two car garage in the Girard Tract and the outer core of the Mulholland Scenic Parkway Specific Plan.

Case Manager: Marty Lipkin, PLUM Committee Member

As pertaining to DIR-2019-4606—DRB-SPP-MSP for a 2-story, 3,406 SF single family residence with 2-car garage at 21075 Topochico Drive, Woodland Hills 91364, having held four (4) public meetings for the application filed by the property applicant Leonard Yaghoobi concerning the new construction of a structure in the Girard Tract and the outer core of the Mulholland Scenic Parkway Specific Plan, the Planning, Land Use and Mobility committee hereby finds that:

Updated rendering of rear (East) façade showing new balcony design and simplified window styling.

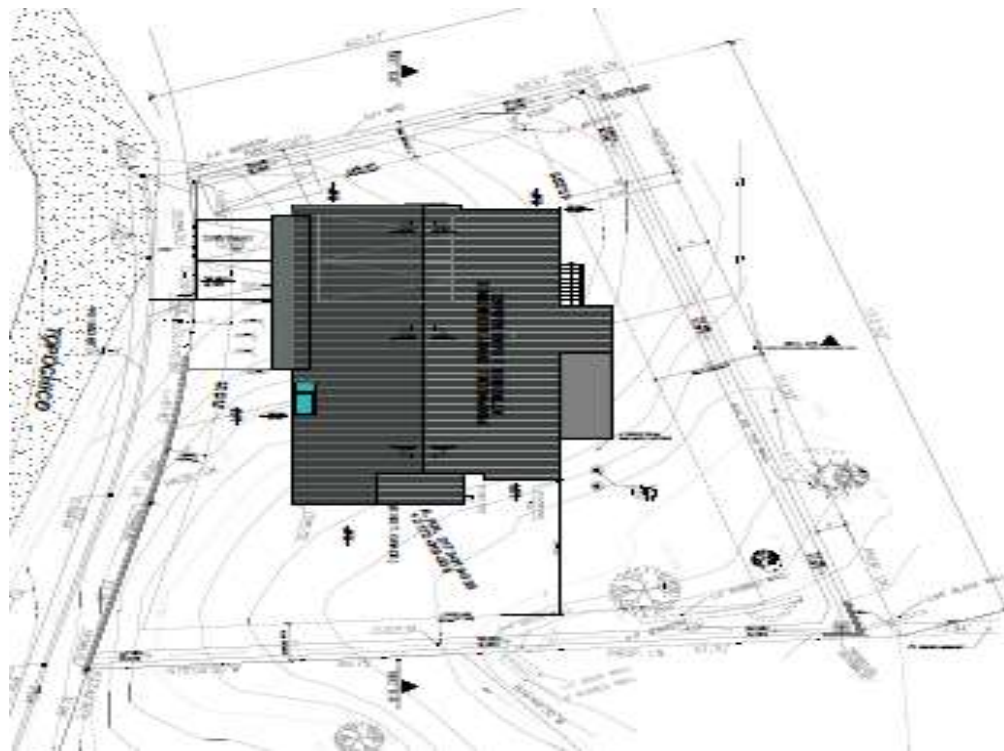
The redesigned/expanded structure features an additional 256 SF of space and significant exterior changes as well as architectural additions and refinements to both the front and rear

elevations of the structure as well as to the south façade including additional windows, a modified front entry, and changes to the rear balcony and staircase.

Site Plan for the proposed structure.

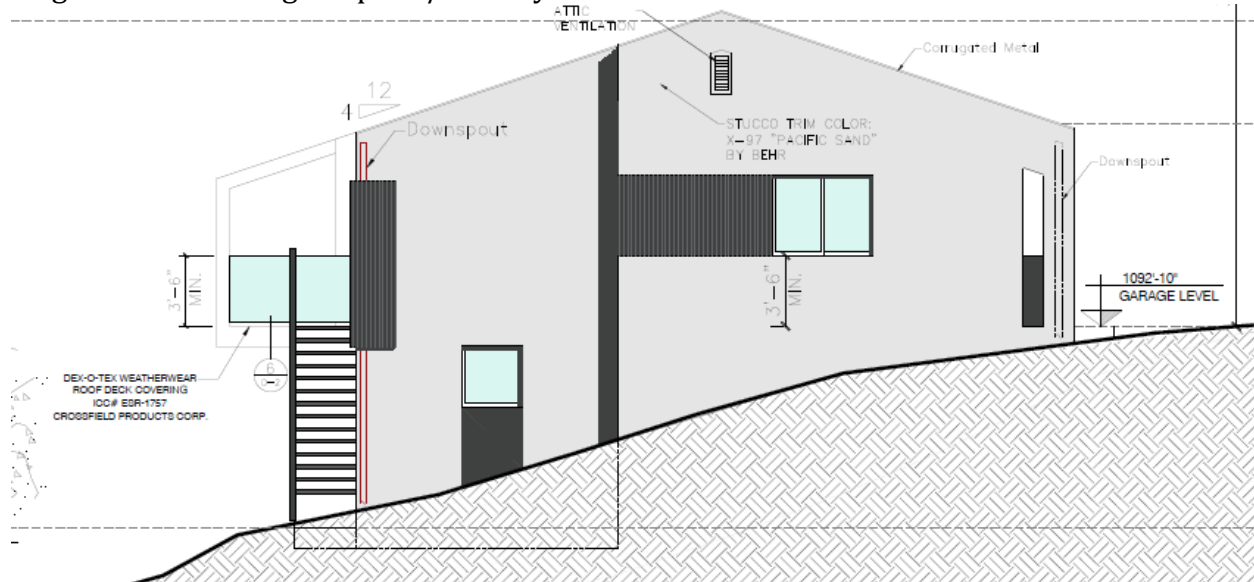
The building meets the baseline Hillside Ordinance minimum required 5' front yard setback along the substandard street, and the minimum 7' side yard setback required for buildings over 18' in height (1' added to side yard requirement of 5' minimum for each increment of 10' above

height.) The substandard street will be widened to 20 feet wide along the width of the applicant's property, as required.

There is a retaining berm along the front street line that rises to just above street level in order to shore up hillside at the front of the home and prevent mud flows. There will be 28 caissons supporting the structure, sunk approximately 20' deep into the hillside. A "bridge" from the street to the garage entrance will have covered/shielded sides to prevent animal habitation and help ward off any erosion.

North elevation showing second floor balcony with iron railings and glass, and decorative “wood” enhancements.

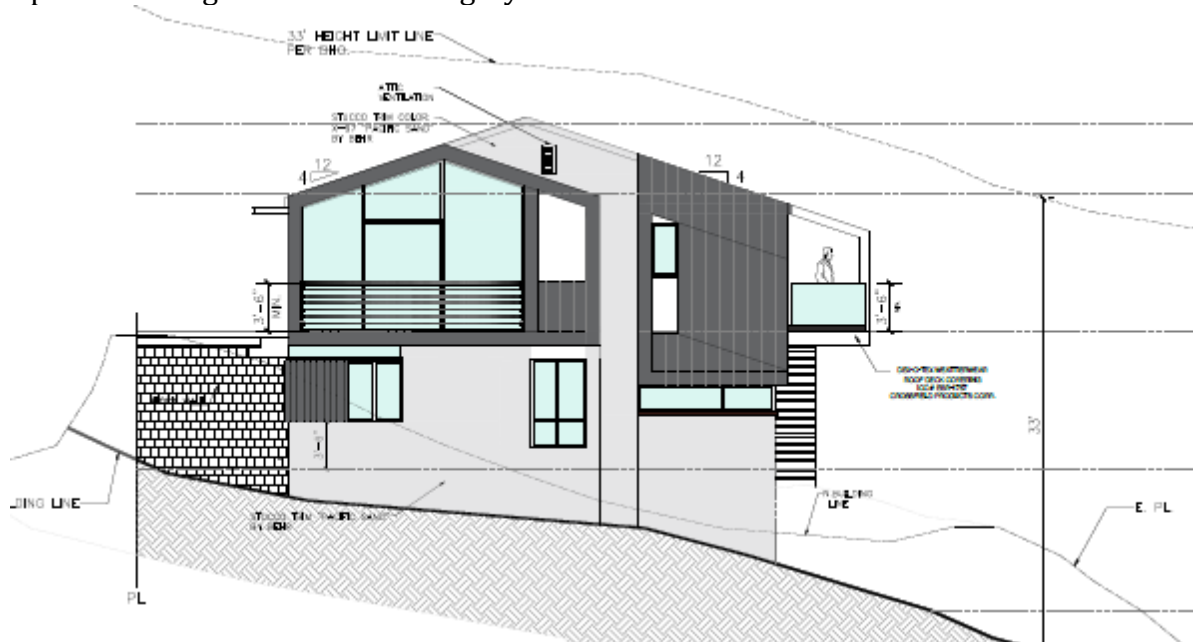
floor of the rear of the structure to the down-sloping hillside, and the project indicates a single steel rail and glass patio/balcony at the rear of the home.
